**CRUISER
AIRCRAFT**

No.: SB-CR-042

SERVICE BULLETIN

MODEL AFFECTED:	PS-28 Cruiser and SportCruiser / PiperSport aircraft under EASA regulation
SUBJECT:	Landing Light Replacement (original TrailTech 4213-SX for TrailTech D112-SX)
AIRCRAFT AFFECTED:	All aircraft according to section "MODEL AFFECTED", as applicable
COMPLIANCE:	Apply this Service Bulletin when replacement of the original Trail Tech 4213-SX landing light is needed

Figure 1 – Dismounting of the Original landing light Trail Tech 4213-SX

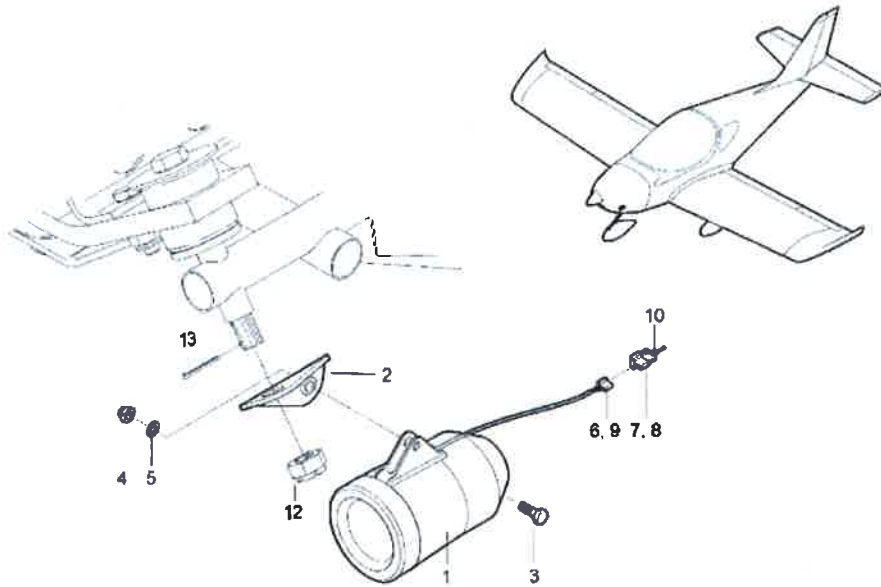
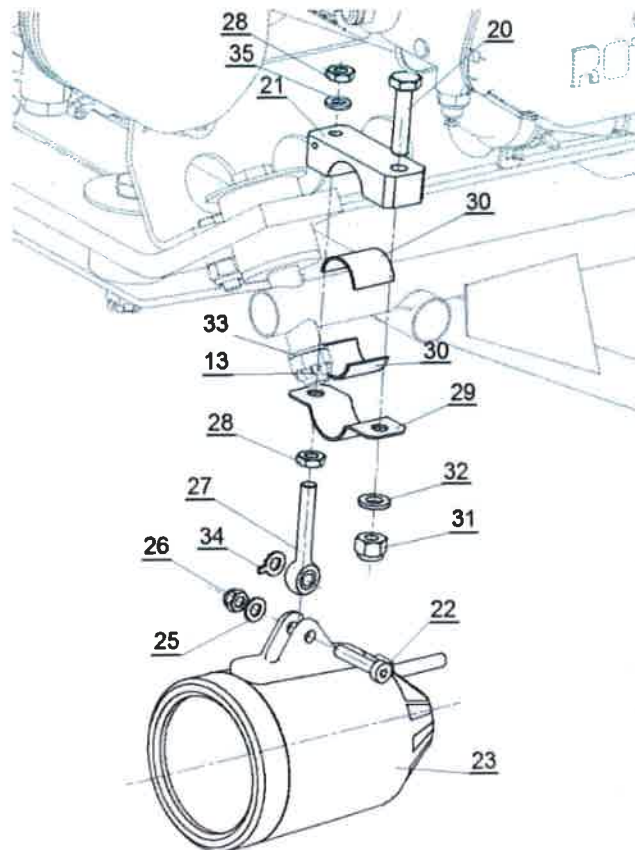
This Service Bulletin contains instructions for replacement of the original landing light Trail Tech 4213-SX (hereinafter also referred to as the "Original landing light") by the new Trail Tech D112-SX landing light (hereinafter also referred to as the "New landing light"). The action also requires replacement of circuit breaker / switch circuit breaker with current rating of 3A.

- 1.7 Disconnect the Original landing light from the aircraft wiring system - cable with the connector (6, 9) from the wiring (7, 8, 10), see Figure 1 above.

- 1.8 Remove the Original landing light (1) with bracket (2) from the engine mount.
- 1.9 Screw back the castle nut (12) and secure with the new cotter pin (13). To eliminate the slackness use the washer (33).

- 1.10 Install the New landing light (23) with the new holder (21, 29, 30) supplied by the Czech Aircraft Group using connecting parts (20, 31, 32, 22, 25, 26, 27, 28, 35), see Figure 2.

Remember that the New landing light can only be operated at 1250 Lumens, otherwise there might be a risk of overloading the 12V DC supply.

Therefore, ensure that the +12VDC voltage is connected to the red and - (0 V) to the black wire.

Figure 3 – The New landing light position adjustment

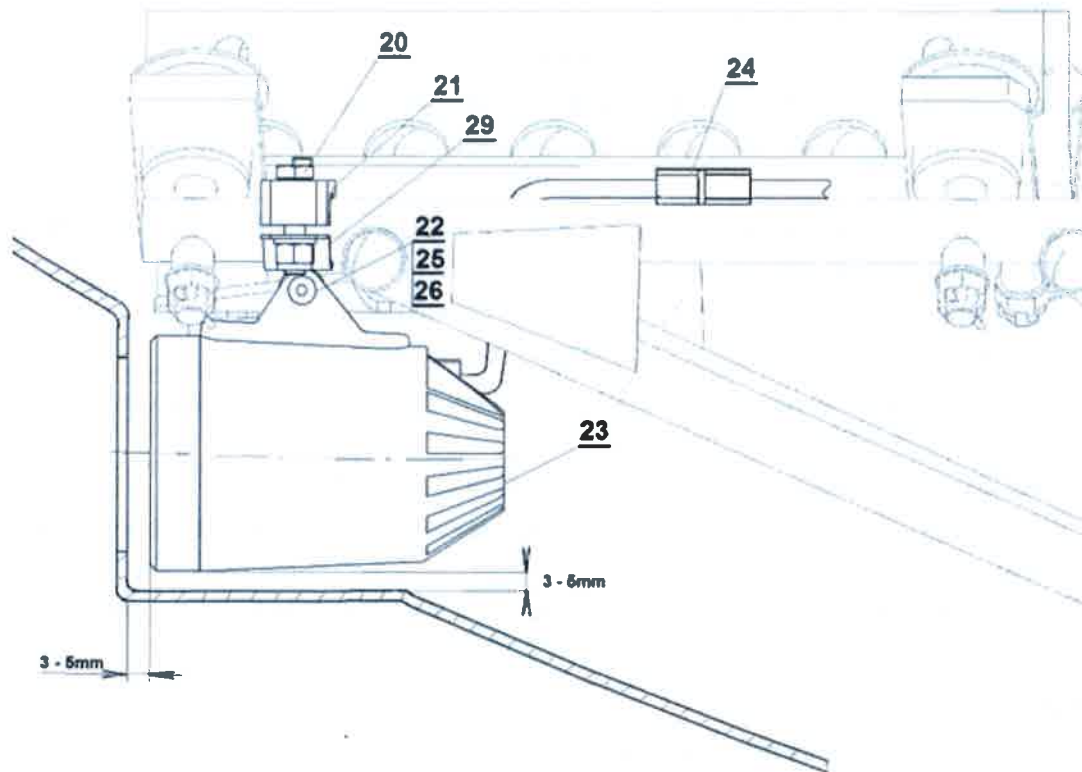
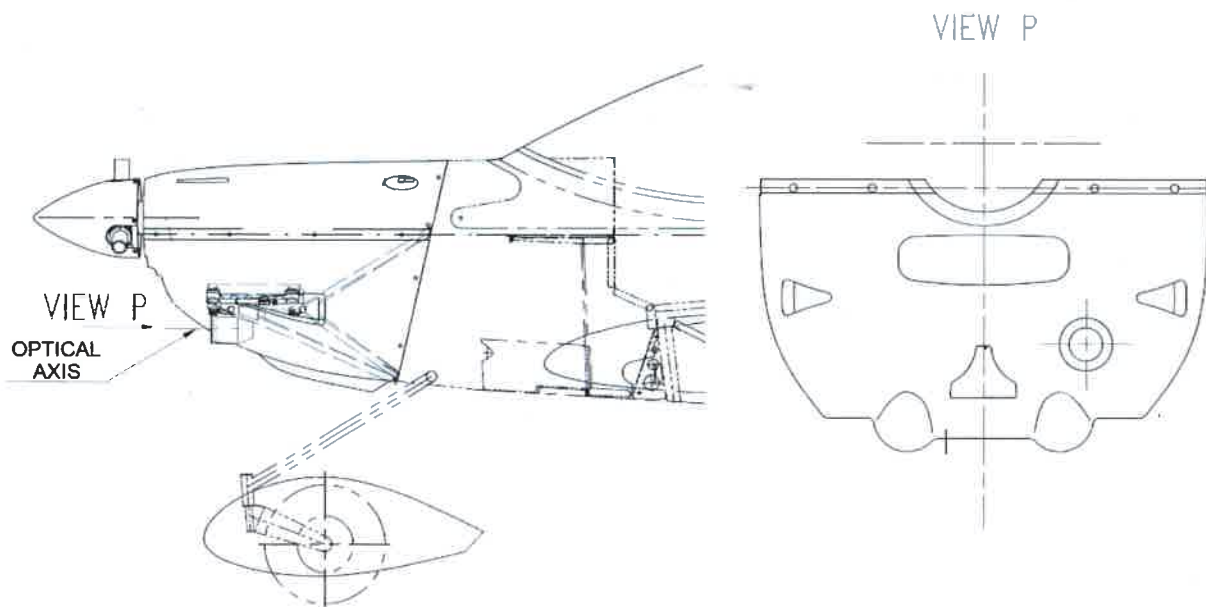
- 1.11 If the gap between the light mounting (23) and the threaded eye (27) on the screw (22) is 0,5 mm or more, insert the washer (34) between the light mounting and the threaded eye. Tighten the screw (22) firmly.
- 1.12 Interconnect the airplane connector (8) with the landing light connector (24), see Figure 1 and Figure 3 above.
- 1.13 Install the engine lower cowling and check the landing light position – it must be adjusted so that the optical axis of the landing light passes through the middle of the engine lower cowling opening, see Figure 3 and Figure 4. Use the parts (21, 29, 30) for adjustment.

- 1.14 Once a correct landing light position is set, remove the engine lower cowling and secure the adjustment by tightening the nut (28) and connecting parts (20, 31, 32).
- 1.15 Find the circuit / switch circuit breaker of the landing light (LDG L) on the instrument panel (see the CR-MM-1-0-00, latest revision) and check the rating. The range of 3A is correct current rating for the New landing light circuit / switch circuit breaker rating.

Figure 5 - The LDG L MS3320-x circuit breaker. Placed on the right instrument panel

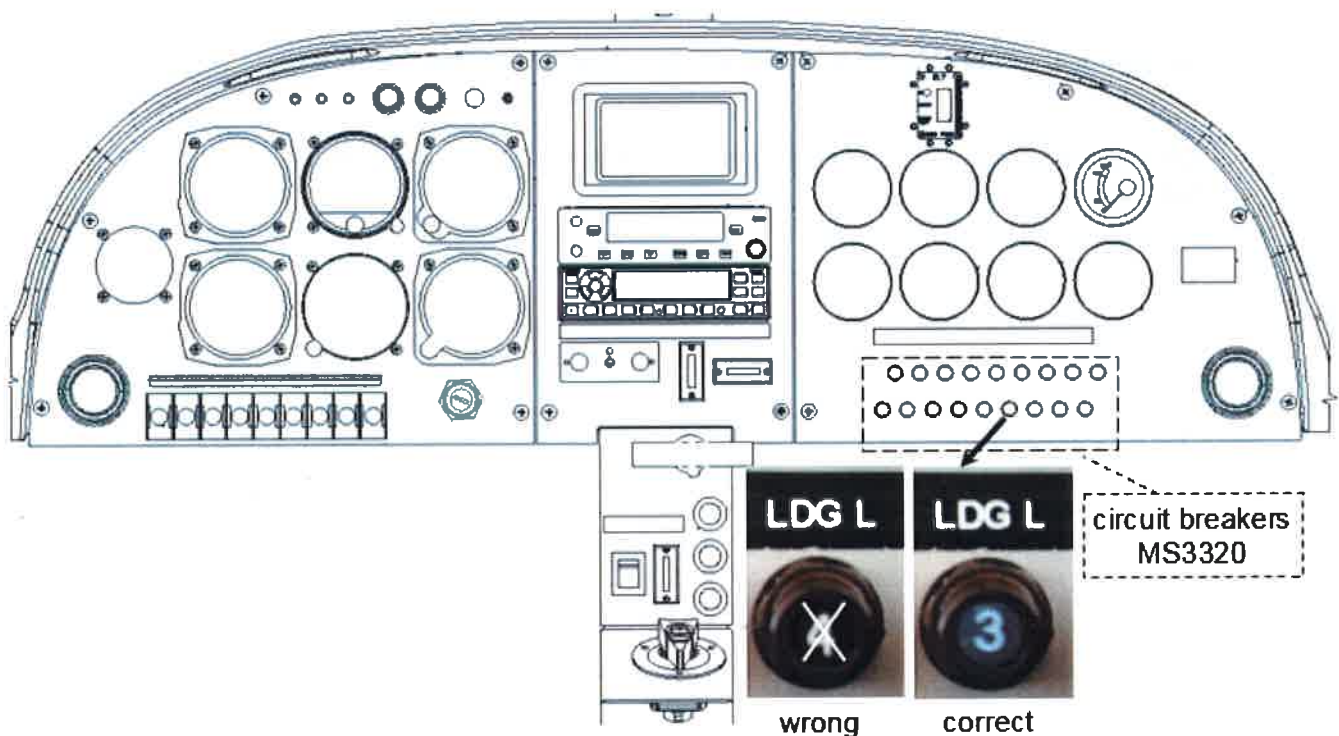
Note: In the **PS-28 Cruiser** airplanes with analogue or **D100/D120** avionics equipment installed, the original MS3320-x circuit breaker has to be replaced by the **MS3320-3 (3A)** circuit breaker (marked "LDG L"). **The circuit breaker is placed on the right instrument panel.**

The MS3320 LDG L circuit breaker is installed on the right instrument panel, see Figure 5, The circuit breaker is marked "LDG L". Replacement of the circuit breaker has no effect on mass and CG of the airplane.

- 2.7 Use the new LDG L circuit breaker from the replacement package (MS3320-3, current range of 3A), see Figure 5. Insert the circuit breaker in the right instrument panel and fix using the nut (2) with the washer (3), see Figure 7.

Figure 7 - MS3320-x circuit breaker removal / installation

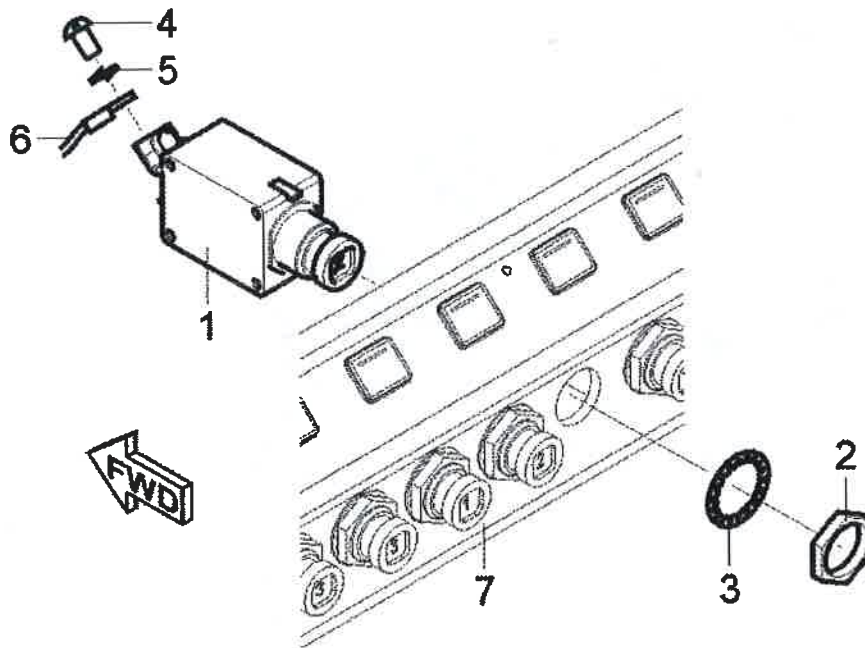
- 2.5 Release the screw (4) with the washer (5) and disconnect the cable (6) from the LDG L circuit breaker, see Figure 7.
- 2.6 Unscrew the nut (2), the washer (3) and remove the original LDG L circuit breaker (1), see Figure 7. To unscrew the nut (2) use the ½ inch wrench.

- 2.8 Connect the cable (6) using the screw (4) with the washer (5), see Figure 7.
- 2.9 Fix the main supply bus (4) back to the all circuit breakers using the screws (2) with the washers (3), see Figure 6.

Figure 8 - The LDG L W31X2M1G-x switch circuit breaker. Placed on the left instrument panel

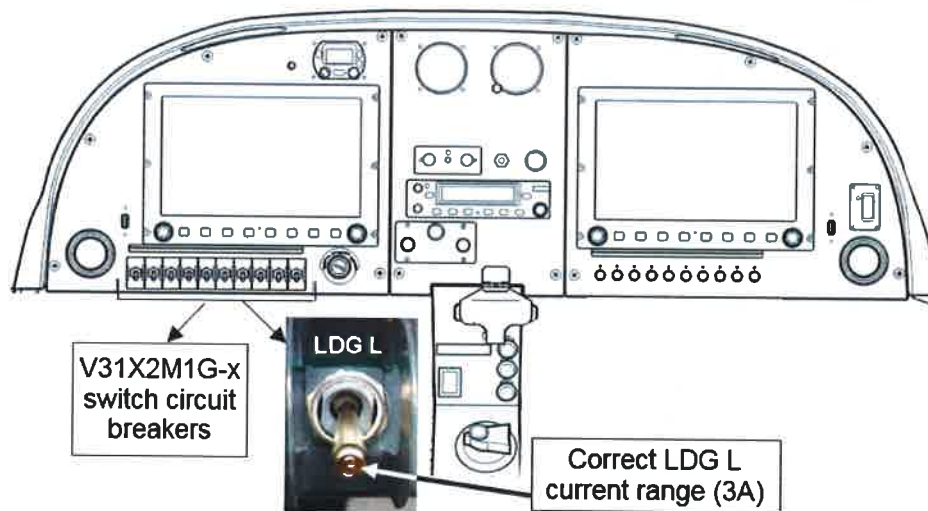
In the **PS-28 Cruiser** airplanes with **Dynon SkyView D1000** installed and in the **Sport Cruiser / Piper Sport** airplanes, the original W31X2M1G-x switch circuit breaker has to be replaced by the **W31X2M1G-3 (3A)** switch circuit breaker (marked "LDG L"). **The switch circuit breaker is placed on the left instrument panel.**

The W31X2M1G-x switch circuit breaker (marked "LDG L") is placed on the left instrument panel. Replacement of the switch circuit breaker has no effect on mass and CG of the airplane.

- 3.1 Determine the LDG L switch circuit breaker (text "LDG L") on the left instrument panel, see Figure 8.
- 3.2 Secure that the MASTER BATT switch is turned off and disconnect the battery terminals, see the CR-MM-1-0-00, point 11.3.2, latest revision.
- 3.3 Release the screws (2) with the washers (3) of all the switch circuit breakers and remove the main supply bus (4), see Figure 9.

Figure 10 - W31X2M1G-x switch circuit breaker removal / installation

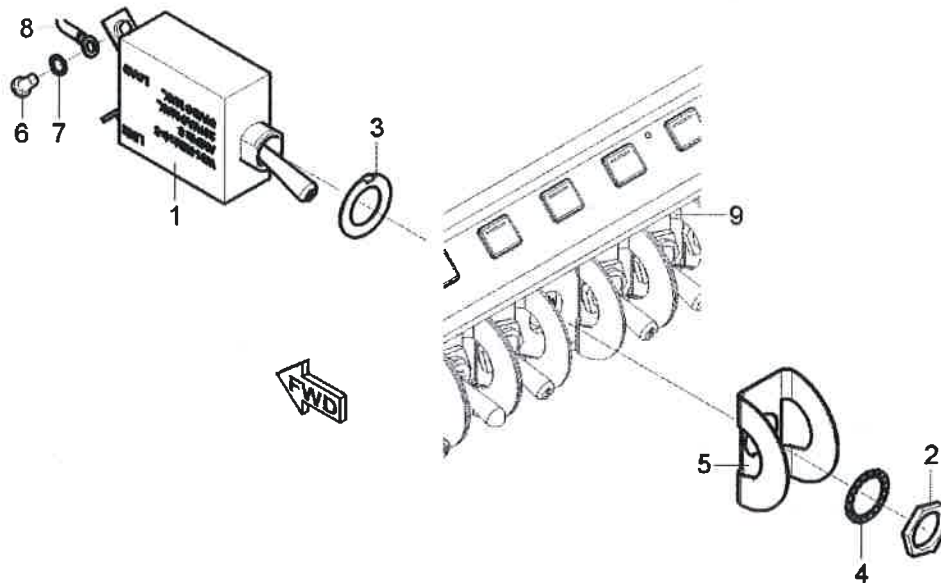
3.4 Remove the nut (2), the washers (3, 4) and cover (5) of the original LDG L switch circuit-breaker (1), see Figure 10.

3.5 Remove the screw (6) with the washer (7), and disconnect the original LDG L switch circuit-breaker cable (8), see Figure 10. Remove the original LDG L switch circuit breaker (1).

3.6 Use the new W31X2M1G-3 LDG L switch circuit breaker (current range of 3A) from the replacement package and insert it in the left instrument panel instead of the original switch circuit bracket. Apply the cover (5) and fix the switch circuit breaker using the nut (2) with the washers (3, 4), see Figure 10.

3.7 Use the screw (6) with the washer (7) and connect and fix the cable (8) to the new switch circuit breaker (1), see Figure 10.
